Maxtor Corporation
500 McCarthy Boulevard
Milpitas, CA 95035 USA

To: T10 SAS Protocol Working Group
Contact: Mark Evans
Phone: 408-894-5310
Email: mark_evans@maxtor.com
Date: 25 August 2003

Subject: SAS-1.1, adding the Terminate Data Transfer protocol service

Figure 1 — ST_I (transport layer for SSP initiator ports) state machines

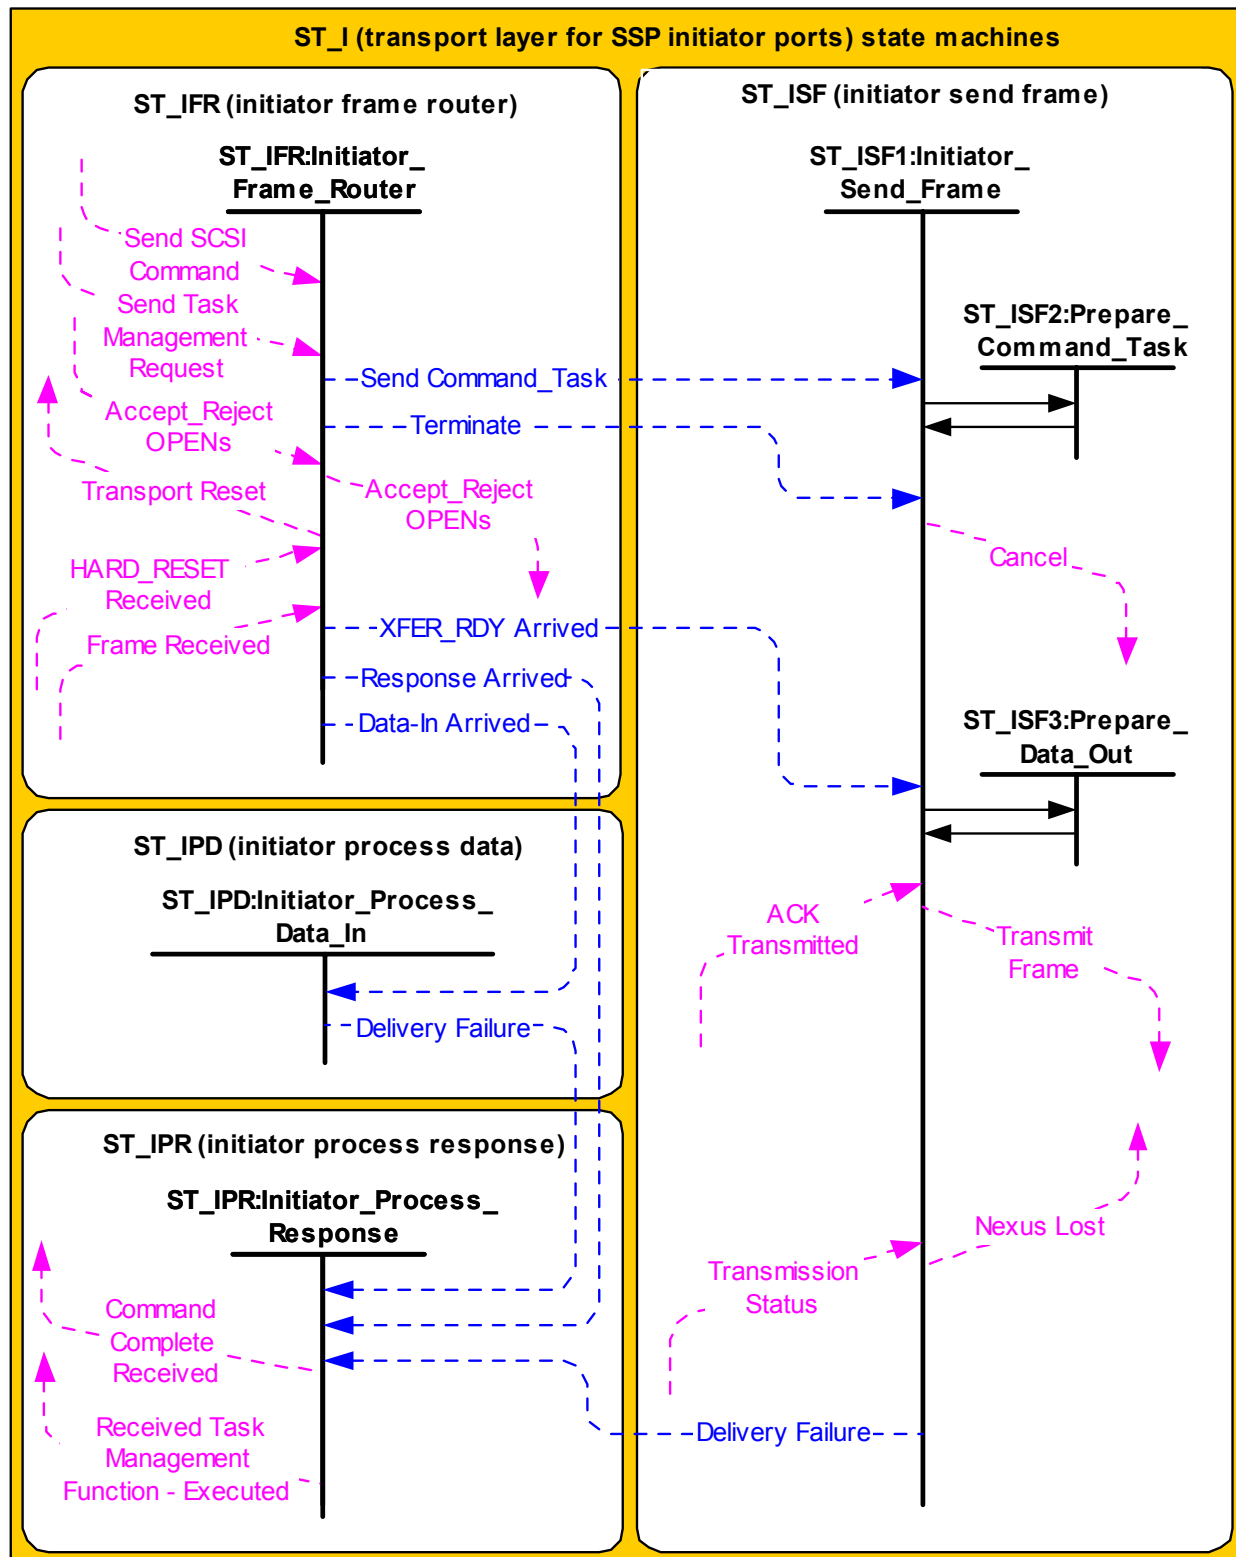
Item 5) In order for tasks to be cleared from SSP initiator ports after a task management request affecting that task has been received, it is necessary for the ST_IFR:Initiator_Frame_Router state machine to be aware of outstanding tasks and task management requests. Because of this, this proposal moves the Send SCSI Command and Send Task Management protocol service requests from being sent to the ST_ISF1:Send_Frame state machine to being sent to the ST_IFR state machine. This makes it so that the flow of the text in the draft standard is better if the ST_IFR description precedes the ST_ISF1 description. The following proposed text makes those changes along with some other editorial changes (note also that the ST_IFR state machine no longer terminates). The following begins with clause 9.2.6.1.

[The only change in the following is the order of the list to reflect moving the ST_IFR description.]

Figure 2 — ST_T (transport layer for SSP target ports) state machines

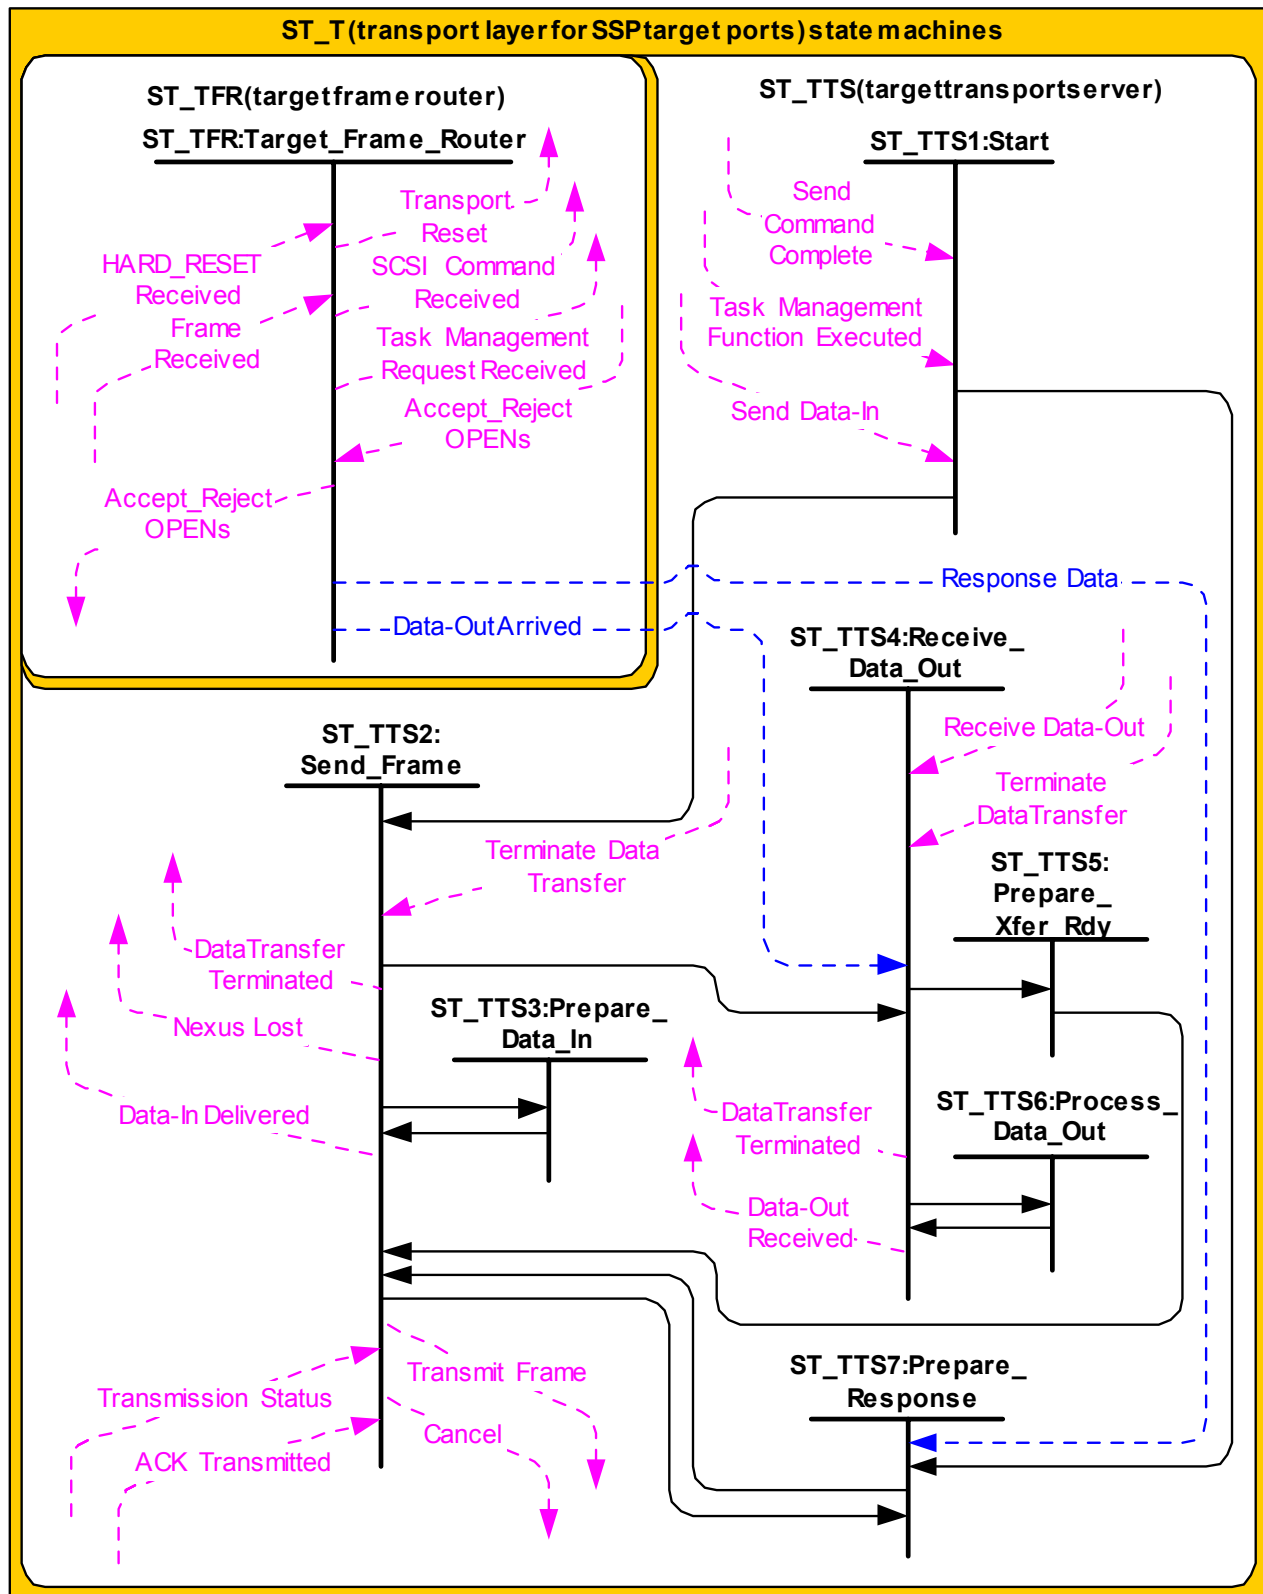
Item 6) In Figure 114 - ST_T (transport layer for SSP target ports) state machines in clause 9.2.6.3.1 ST_T state machines overview add:

- a) a Terminate Data Transfer request from the application layer to ST_TFR:Target_Frame_Router;
- b) a Data Transfer Terminated confirmation from ST_TFR:Target_Frame_Router to the application layer;
- c) a Terminate message from ST_TFR:Target_Frame_Router to ST_TS2:Send_Frame; and
- d) a Terminate message from ST_TFR:Target_Frame_Router to ST_TTS4:Receive_Data_Out.

These changes are shown in the following figure.
